**DOCUMENT 00 90 00**  
**ADDENDUM**

**ADDENDUM NO. [2]                      Date: September 3, 2020**

**RE:                      CITY OF SPARTA  
                             SPARTA POLICE STATION LAKEVIEW  
                             711 PINE STREET  
                             SPARTA, WISCONSIN 54656  
                             HSR PROJECT NO. 19042**

**C400**

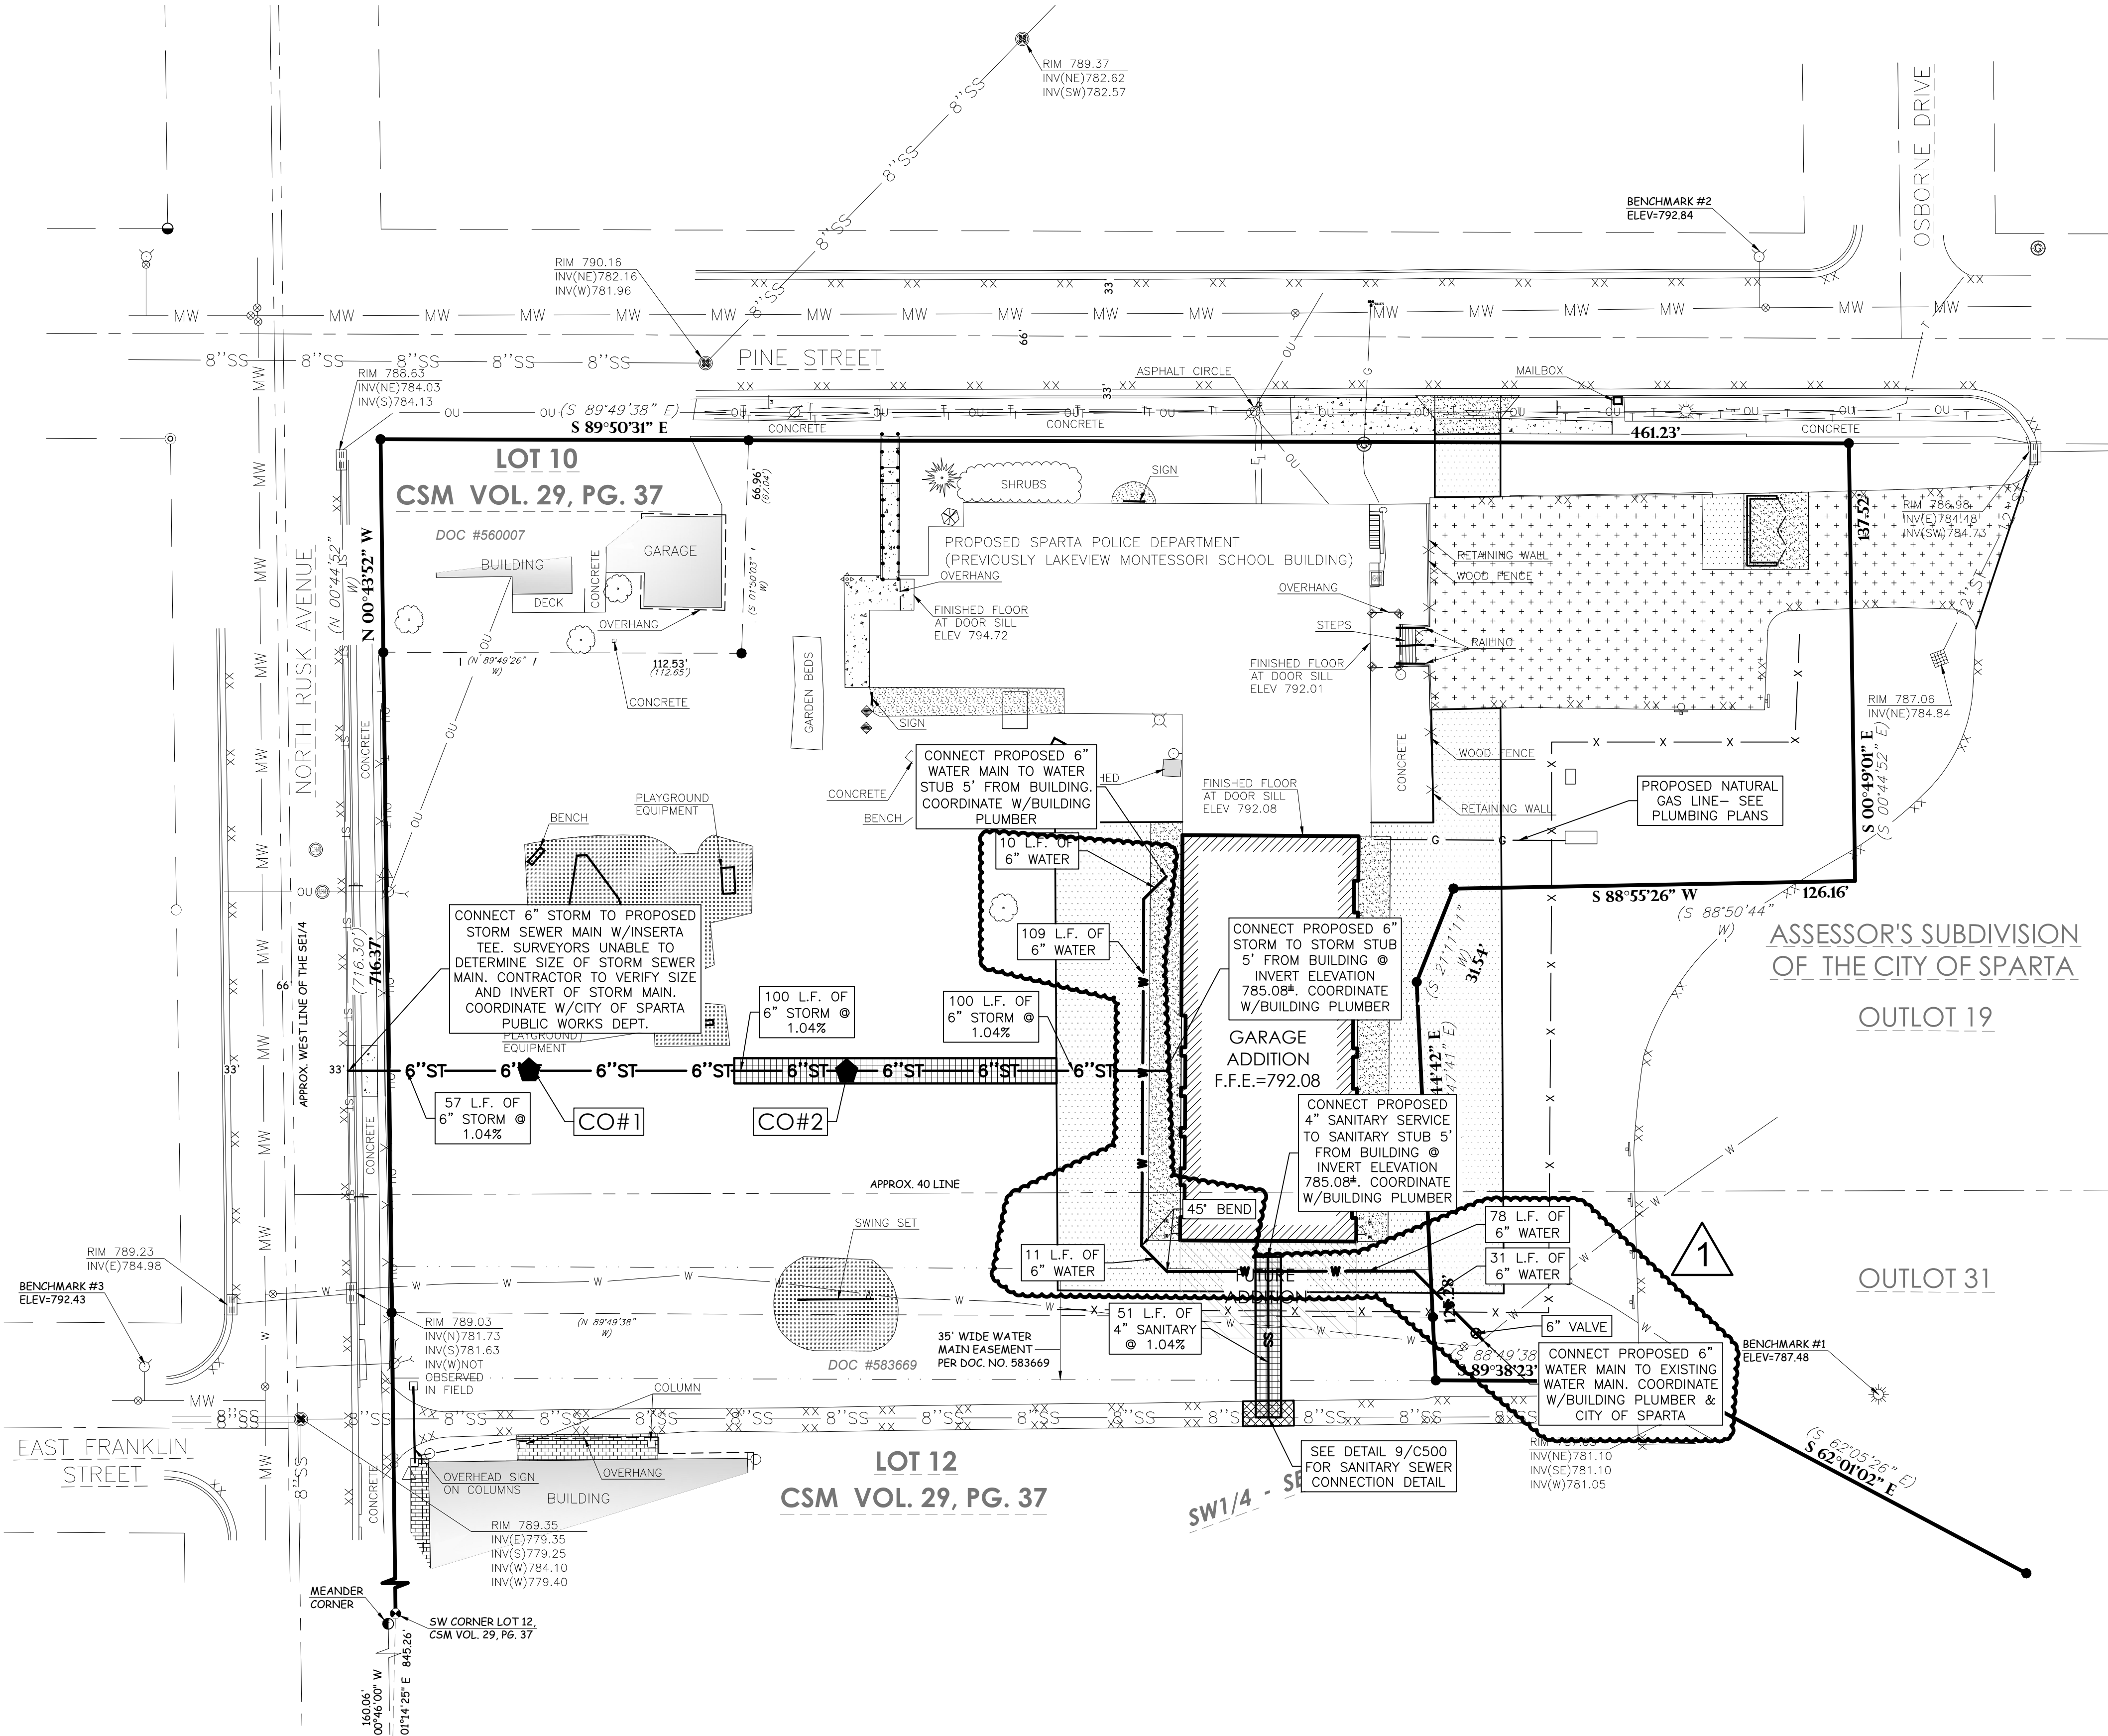
4. Sheet C400 UTILITY PLAN 30 x 42 attached
  - a. Revisions clouded on Drawings.
  - b. Update to new water service.

**1 FIRST FLOOR REMOVAL PLAN**  
1/8" = 1'-0"

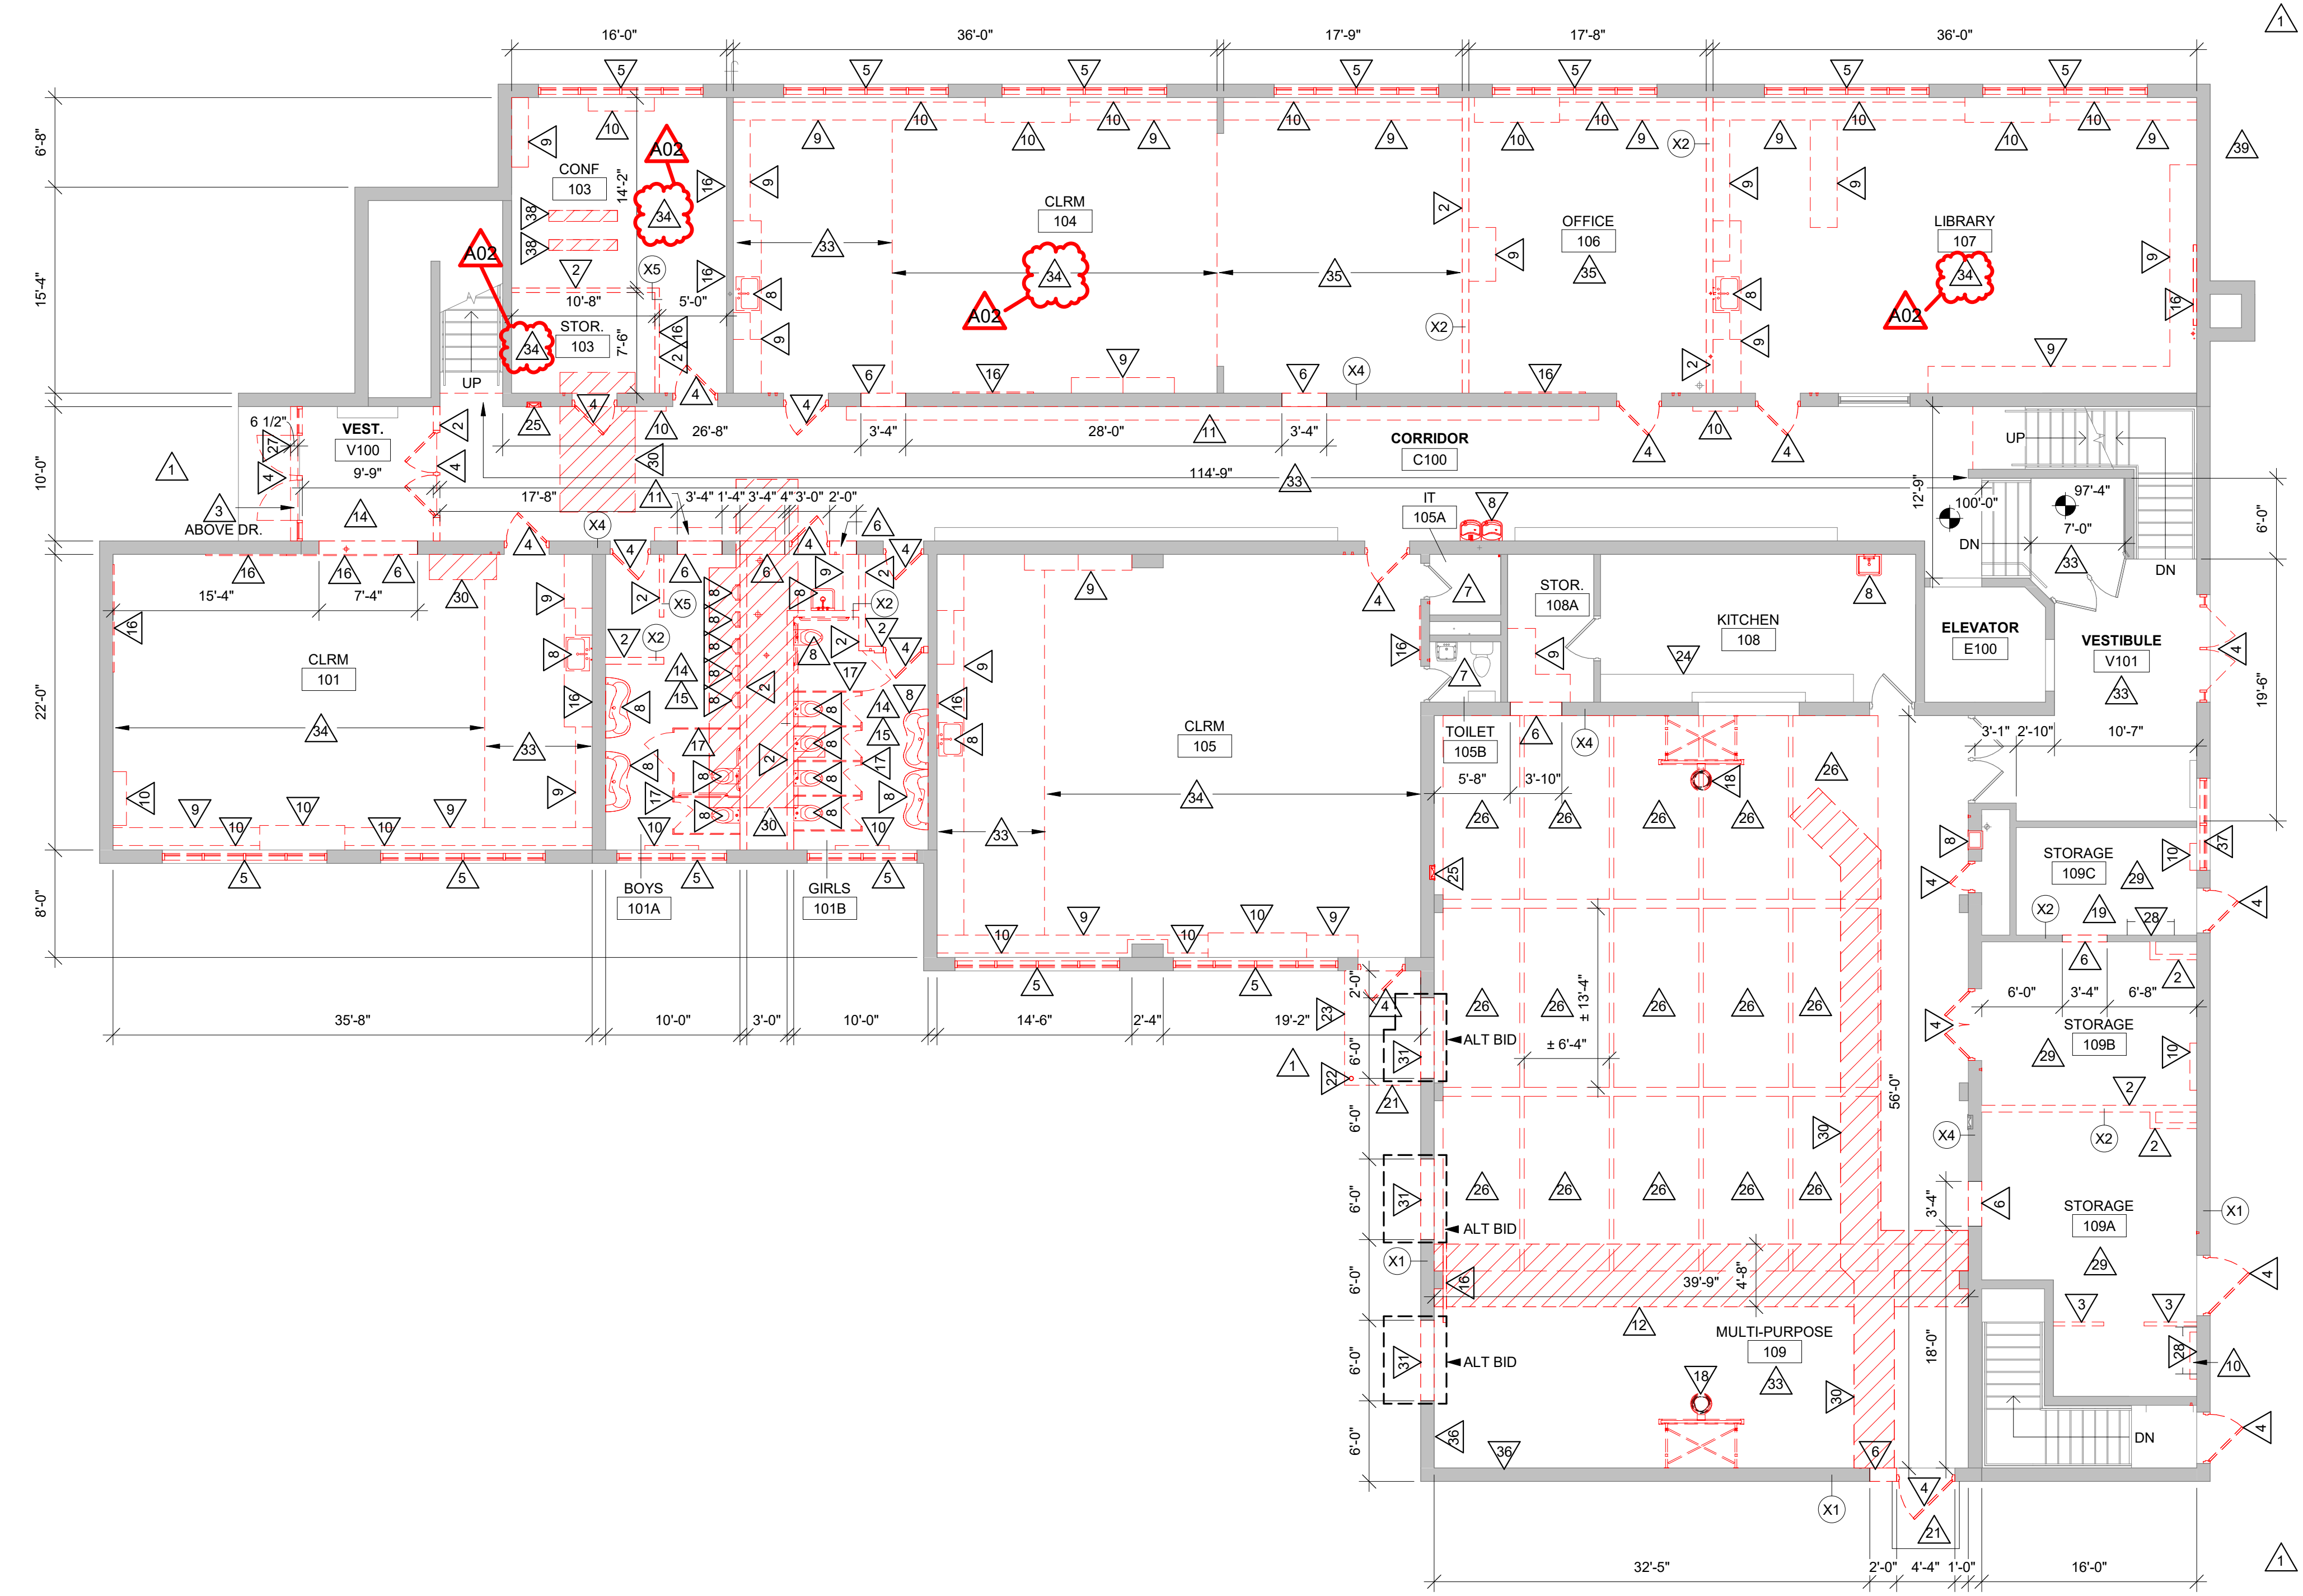
1. Sheet A091 FIRST FLOOR REMOVAL PLANS 30 x 42 attached hereto
  - a. Revisions clouded on Drawings.
  - b. Additional carpet removal deleted from Contract. Asbestos abatement required carpet adhesive to be removed. Revisions to noted references added in Addendum 1 Drawing

**1 SECOND FLOOR REMOVAL PLAN**  
1/8" = 1'-0"

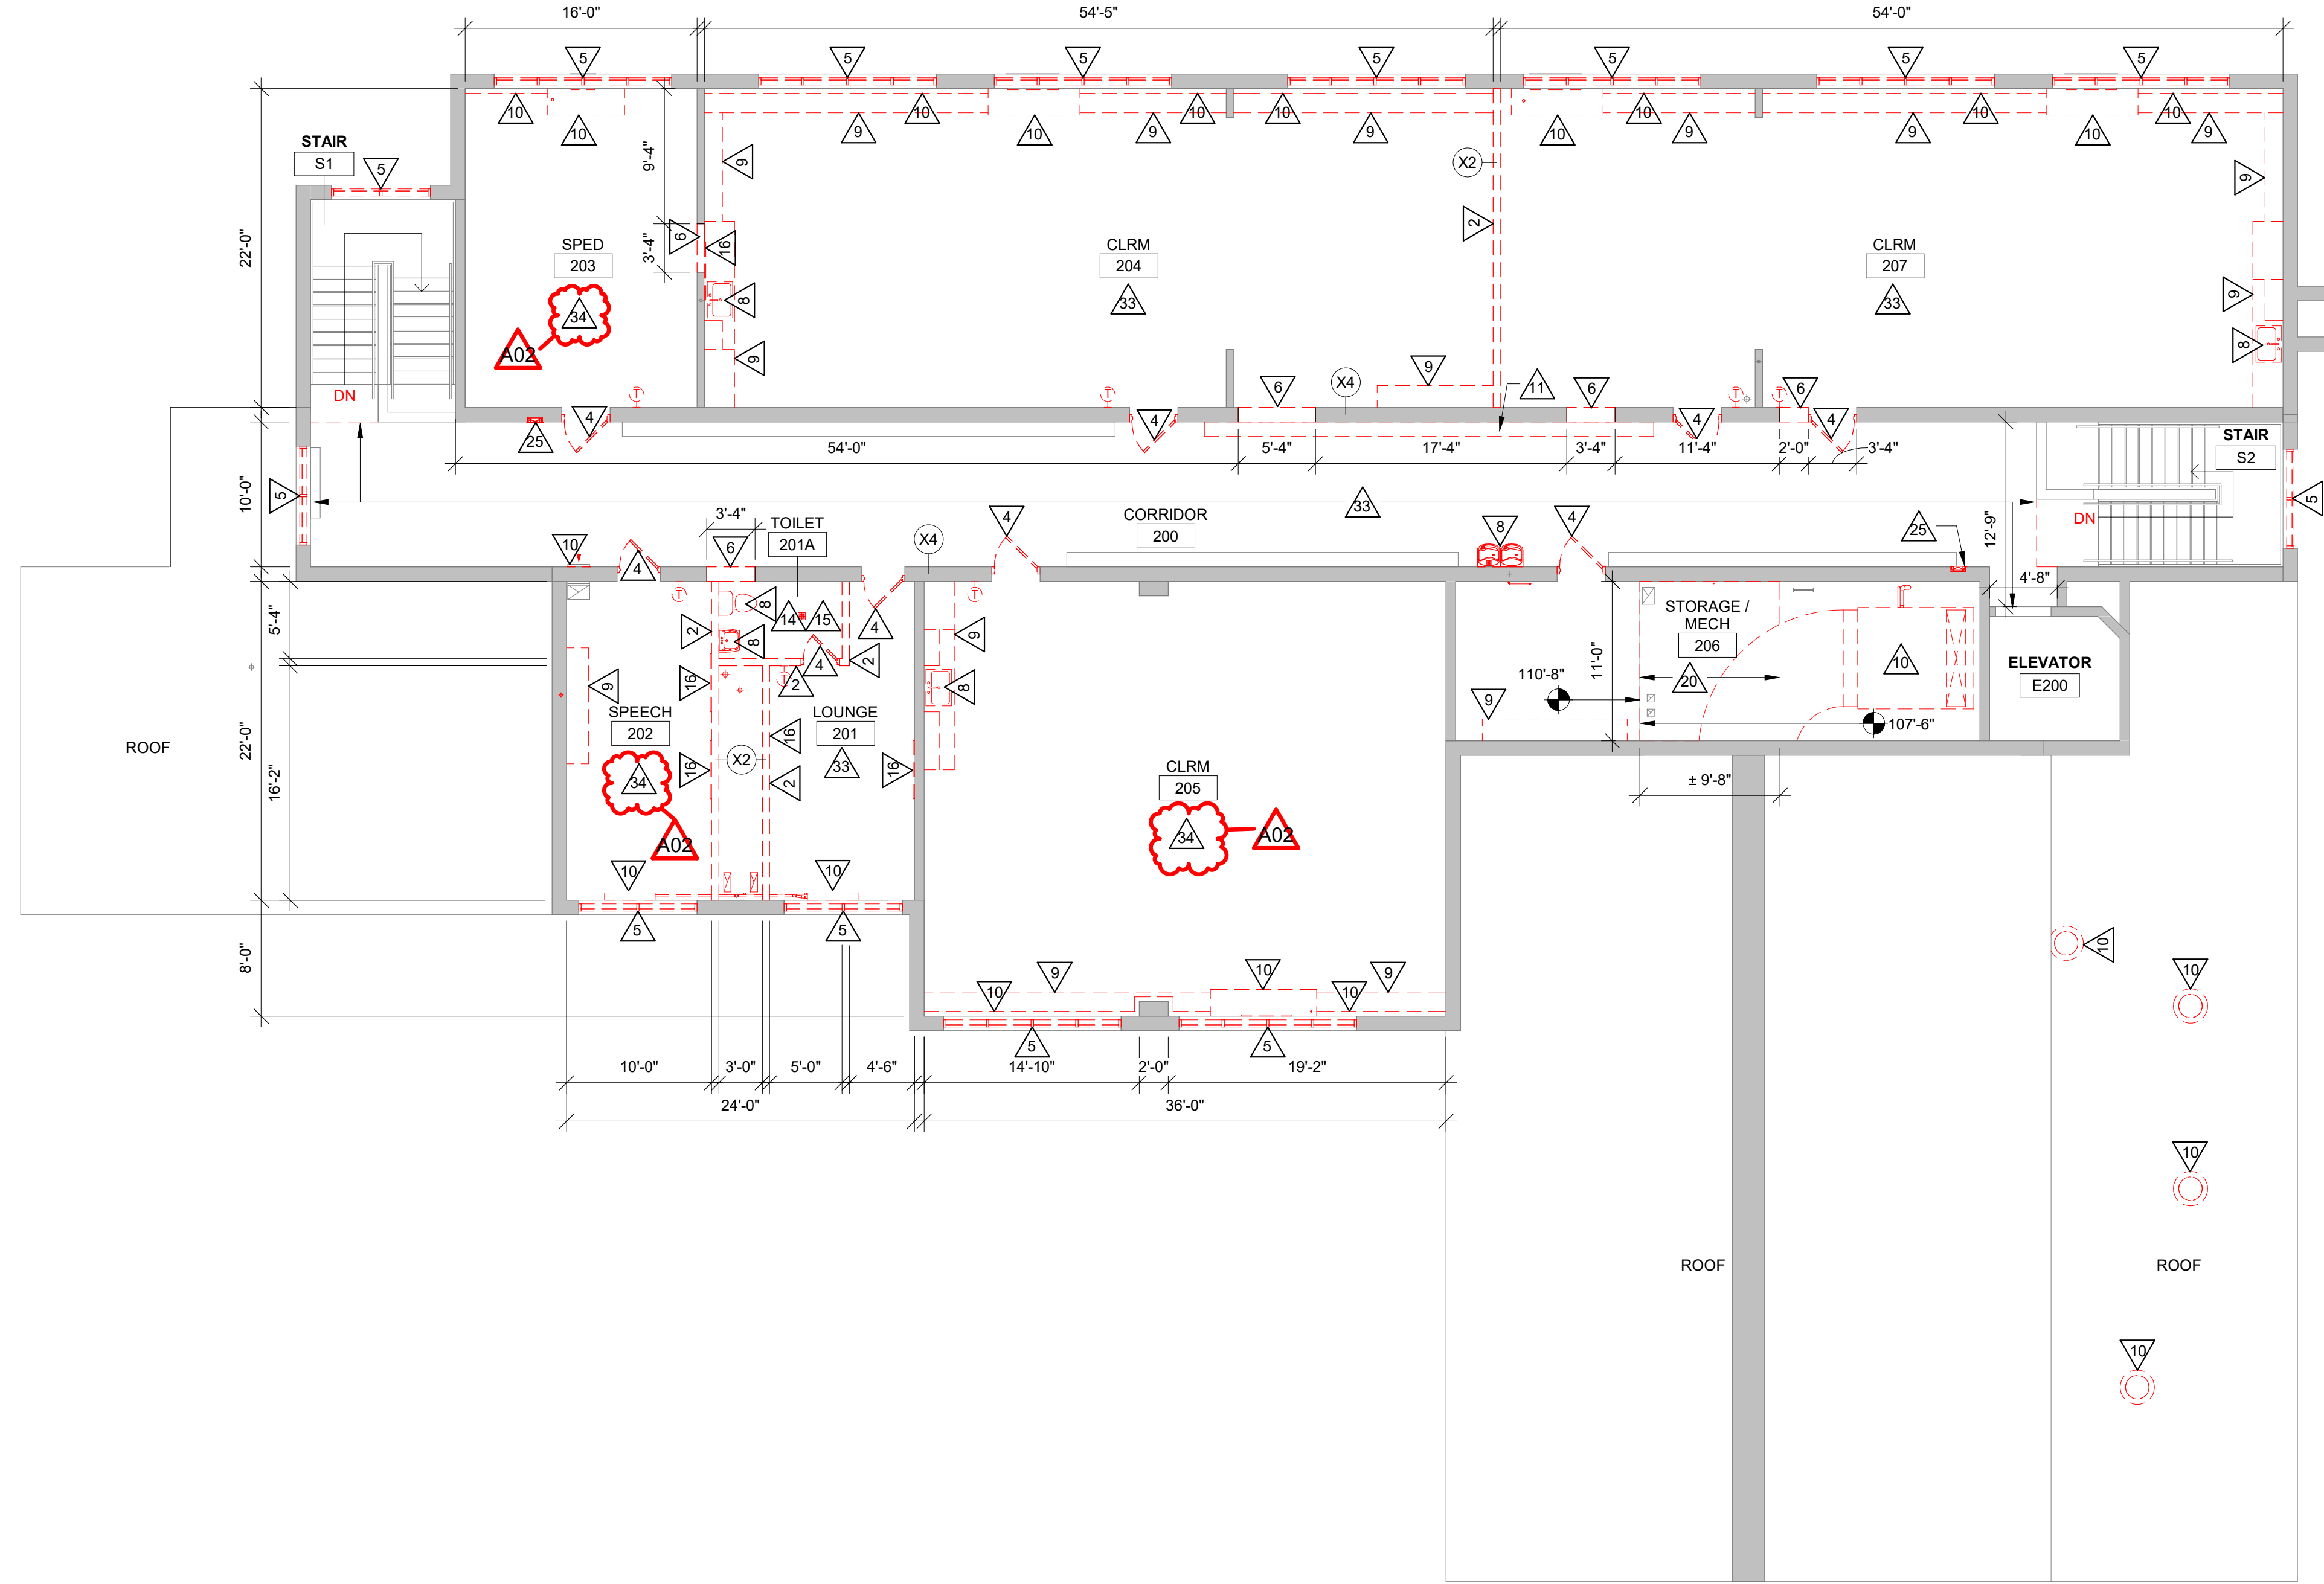
5. Sheet 092 SECOND FLOOR REMOVAL PLANS 30 x 42 attached hereto
  - a. Revisions clouded on Drawings.
  - b. Additional carpet removal deleted from Contract. Asbestos abatement required carpet adhesive to be removed.
